**AN AMENDMENT TO THE
MASTER DRAINAGE DEVELOPMENT PLAN
FOR
WATERVIEW**

WATERVIEW NORTH

November 2020

PROJECT NO. 02-19-05

POST DEVELOPMENT DRAINAGE PLAN

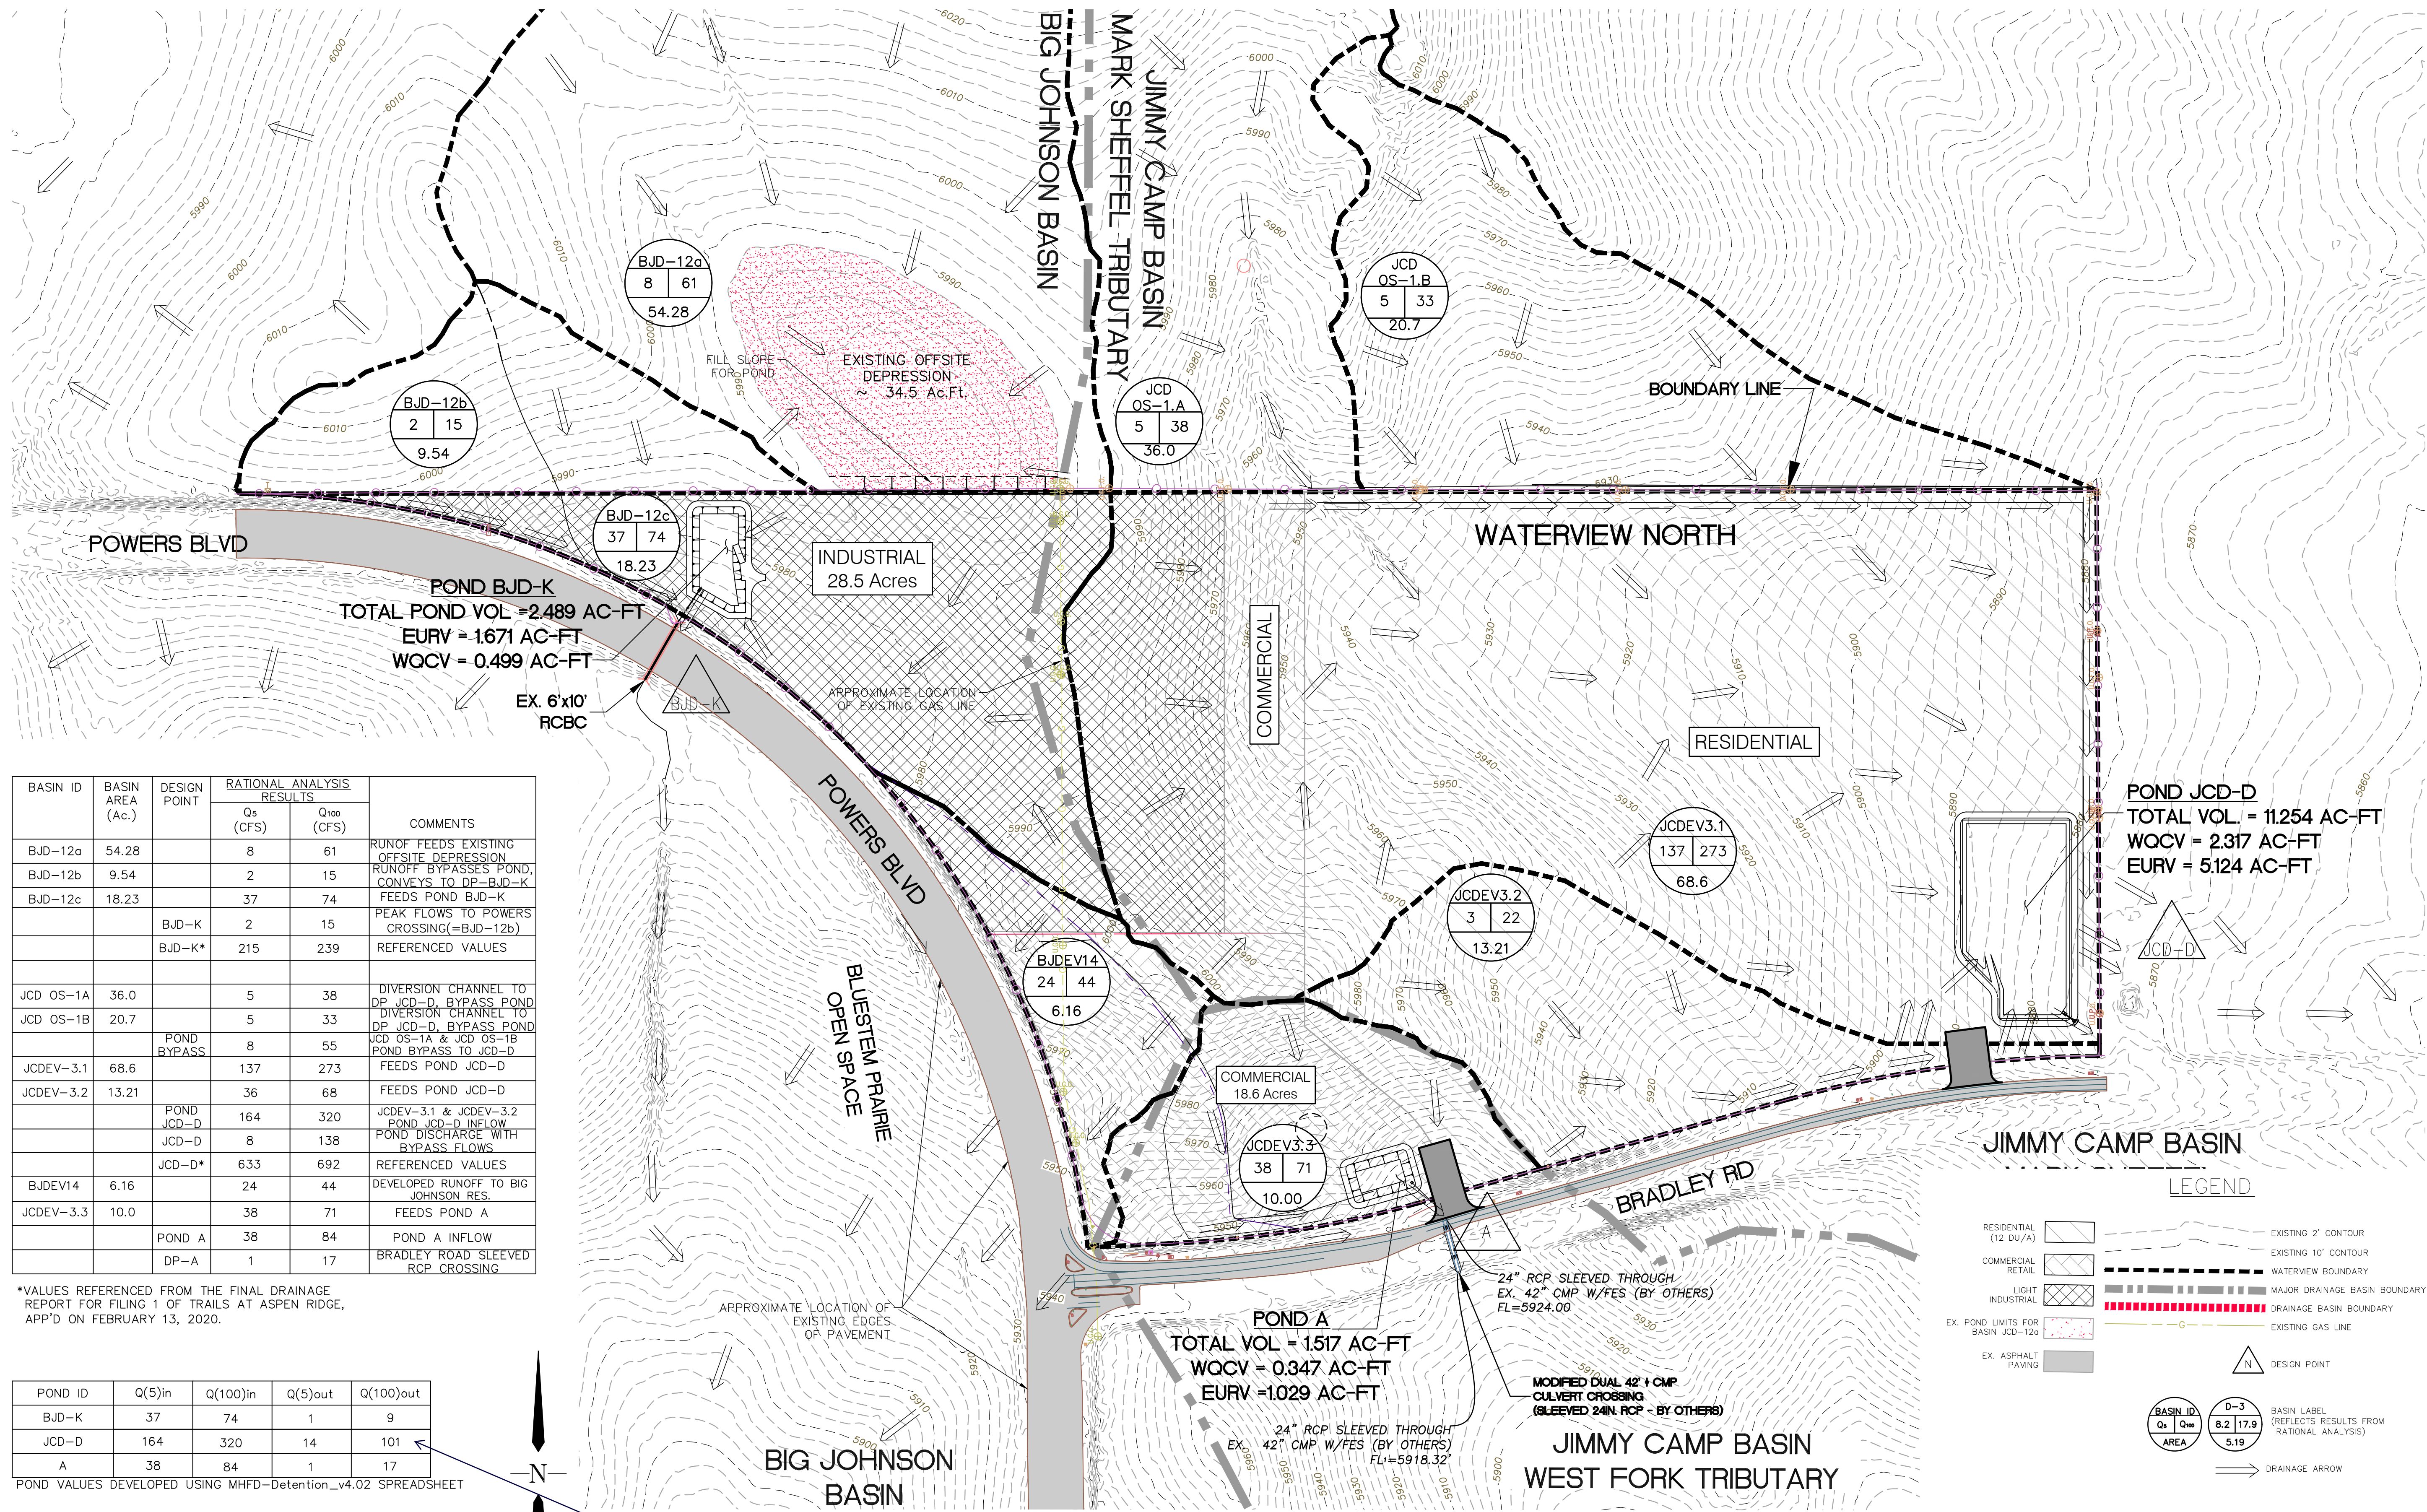
Flow at DP JCD-D must be equal to or less than historic. The pre-development map notes (12 and 84 cfs) Update drainage design/pond release.
